# AGENDA

2. 22-0014 Halifax Self Storage

CITY OF COLUMBIA TENNESSEE  
 ARCHITECTURAL DESIGN REVIEW  
 STAFF REPORT

**ART 22-0014**

NORTH ELEVATION - BUILDING NCC-283

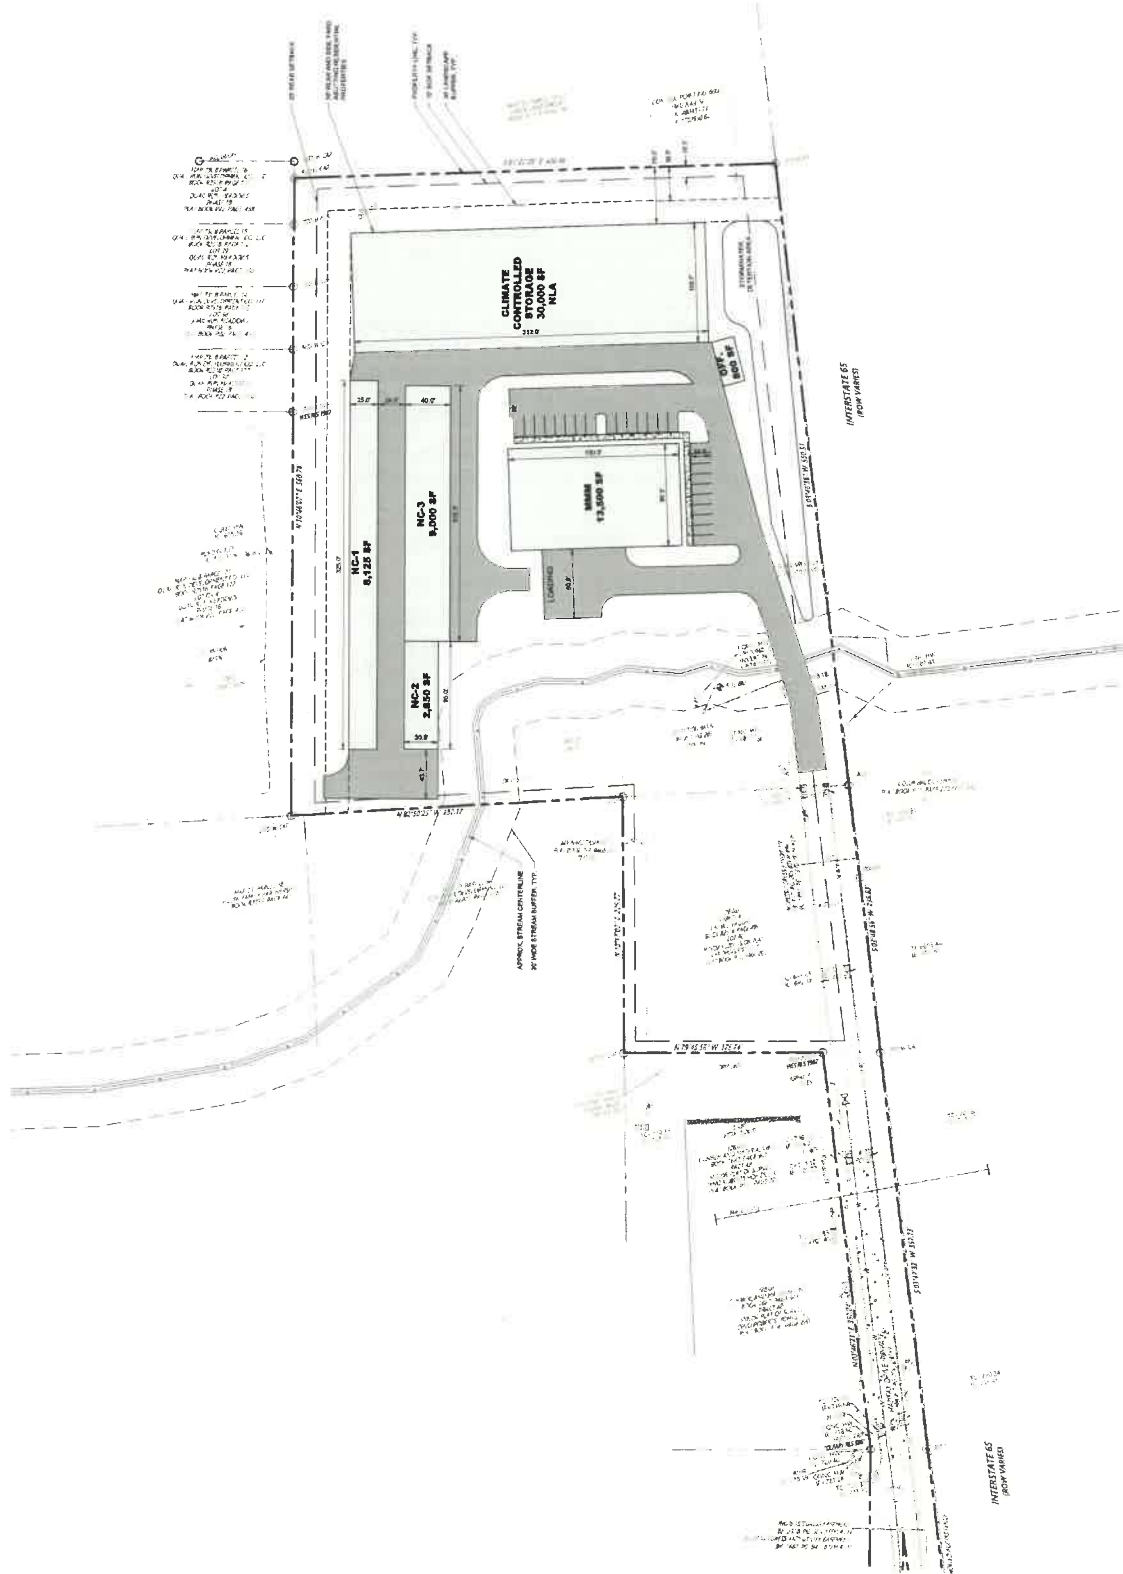
- Building NC 2-3 will be a 40 X 225 structure with an additional inset of a 95 X 30 self-storage structure. The façade material of the structure will consist of fiber cement board siding accented by fiber cement clad pilasters every 28'4" on the east and west elevations, with pilasters every 28' on the east and west elevation. This proposal would meet the guidelines as described for material and articulation.
